Humana Apparels Pvt. Ltd

25 June 2025

2. Observations

Observation-2: Design Report needs to be updated (Utility Building).

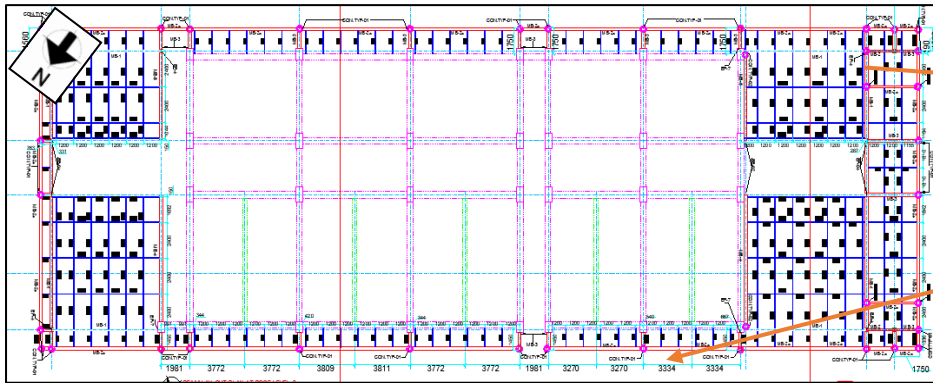
Description: Utility building has been designed in accordance with NBC 2020 considering Special Moment Resisting Frame (SMRF). Flexural members of the SMRF system have to comply with Sec. 8.3.4.1(b) of NBC 2020. However, several beams in the structural system observed not complying with this requirement. The building engineer is required to revise the design and design report with appropriate framing system complying with Table 6.2.19 and Sec 8.3 of NBC 2020.

2.		Carry out remedial work if required.	within 6 months
3.	Design Report needs to be updated (Utility Building).	The building engineer is required to revise the design report for the appropriate framing system complying with Table 6.2.19 and Sec 8.3 of BNBC 2020.	within 6 weeks

Observation-3: Mismatch in as-built drawings (Utility Building).

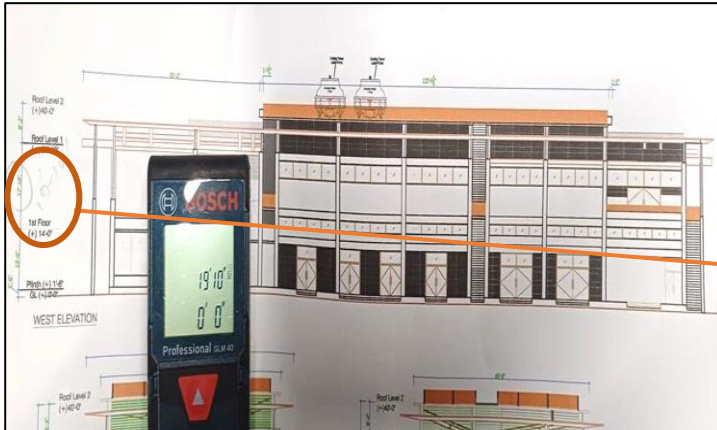
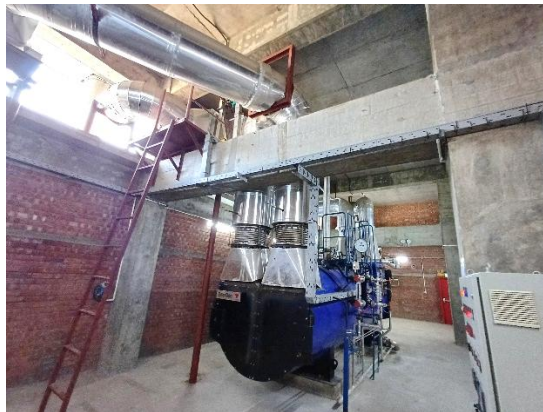
A steel pipe tray connected to the steel part which is absent in as-built drawings.

Floor to ceiling height was observed 6.04 m instead of 5.44 m.

Gardening at the roof – not shown in the drawing

Description: During the inspection, mismatches were found between the onsite condition and the as-built drawing. Water tank and roof top gardening was not shown in the drawing. Also, steel pipe tray is connected to the steel portion which has not shown in drawings. The building engineer is required to survey the full structure and produce accurate as-built drawings.

4.		Carry out remedial work if required.	within 6 months
5.	Mismatch in as-built drawings (Utility Building).	The building engineer is required to survey the full structure and produce accurate as-built drawings.	within 6 weeks
